SHINE Technologies, LLC Application for an Operating License Supplement No. 22 and Revision 1 of the SHINE Response to Request for Additional Information 7-15

**TECHNICAL REPORT NUMBER TECRPT-2018-0028, REVISION 2  
HIPS PLATFORM APPLICATION SPECIFIC ACTION ITEM REPORT FOR  
THE TRPS AND ESFAS**

#### **REVISION 1 OF THE SHINE RESPONSE TO REQUEST FOR ADDITIONAL INFORMATION 7-15**

**Figure 7-15-1: TRPS and ESFAS Gateway Communications Architecture**

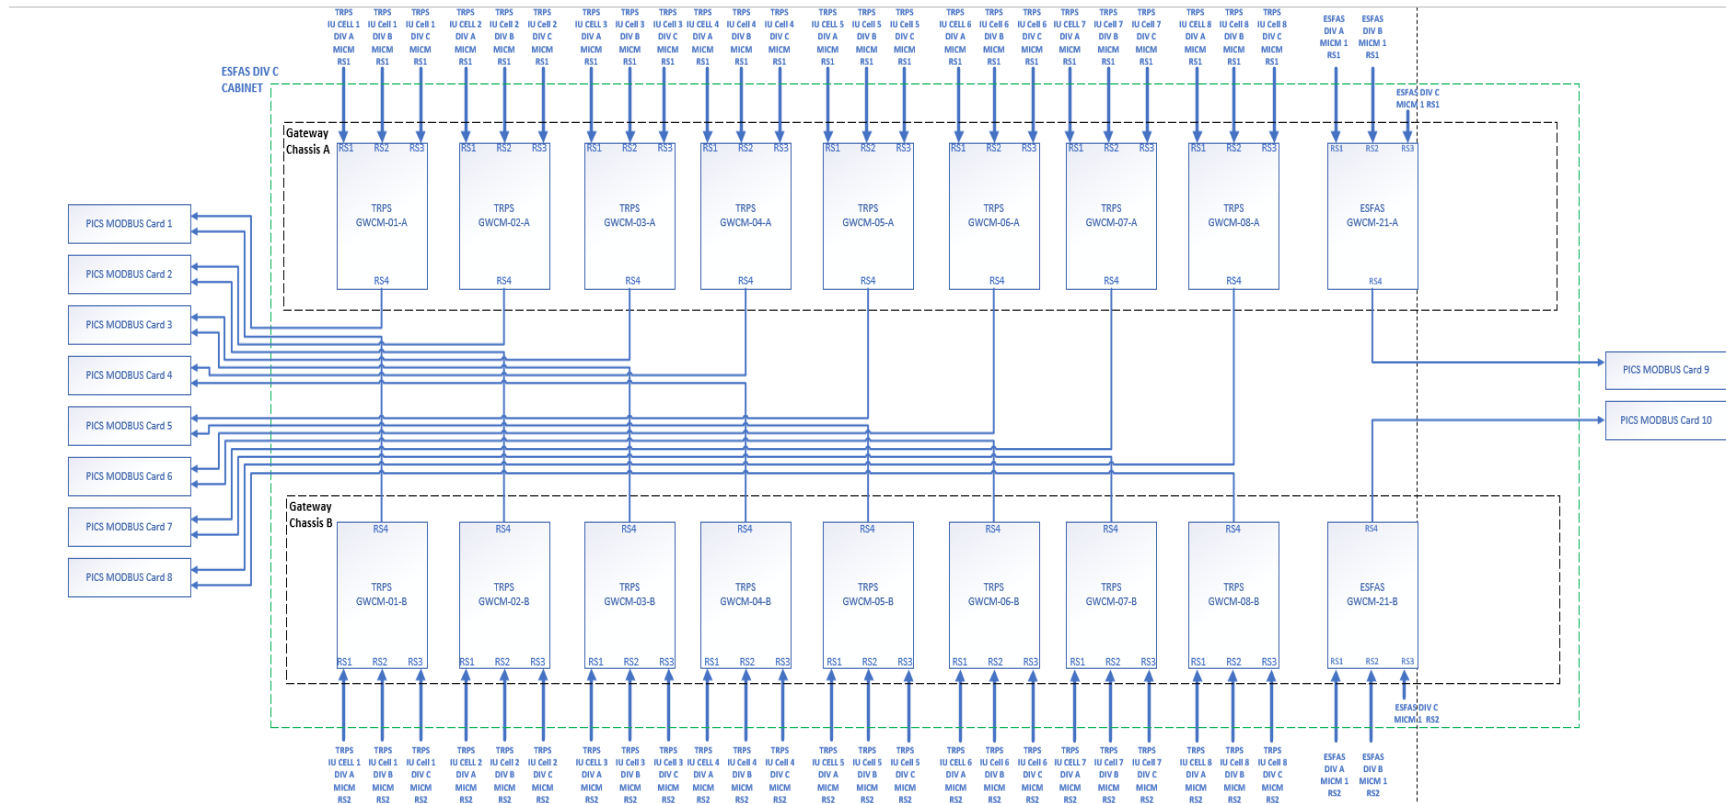
Update the SHINE FSAR to describe how diagnostic and maintenance features are implemented in the HIPS equipment for the TRPS and ESFAS. Demonstrate that the features provide necessary test coverage. Also, demonstrate that the use of these features won't prevent the systems from performing their safety and protection functions.

The NRC staff need this information to verify that testing and maintenance of the TRPS and ESFAS will ensure operability of the equipment and meet the SHINE Design Criterion 15. The information requested above is necessary to support the evaluation findings in Section 7.4 of NUREG-1537, Part 2, including that "[t]he design reasonably ensures that the design bases can be achieved, the system will be built of high-quality components using accepted engineering and industrial practices, and the system can be readily tested and maintained in the design operating condition."

- Modification of configurable variables and setpoints
- Features and limitations to perform in-chassis calibration
- Surveillance tests using automatic sensor cross-check
- Test and calibration functions of the HIPS platform and compliance with regulatory guidance
- Validation of self-testing functions in HIPS equipment

The TRPS and ESFAS have redundant gateways which gather the output of the monitoring and indication communications modules (MICMs) for each of the three divisions, as depicted in Figure 7-15-1 Revision 1. The data for each of the three divisions are compared to perform a channel check, and the results are provided to the process integrated control system (PICS).
